Access Compliance Report Public Rights-of-Way (Curb Ramps)

Main Street: ORANGE_OLIVE_RD Cross Street: E_WHITECAP_AVE Location: NE

ADA ID: RPAT210924142603 Ramp Type: Type 3 - Combination 1 Initial Pass/Fail: Pass Overall Compliance: No Severity Score: 0

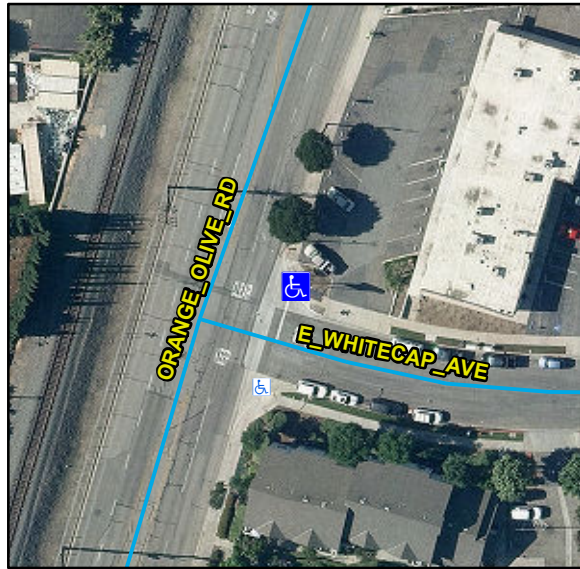
Remove & Replace Curb Slope.

R304.2.2, STD 1115
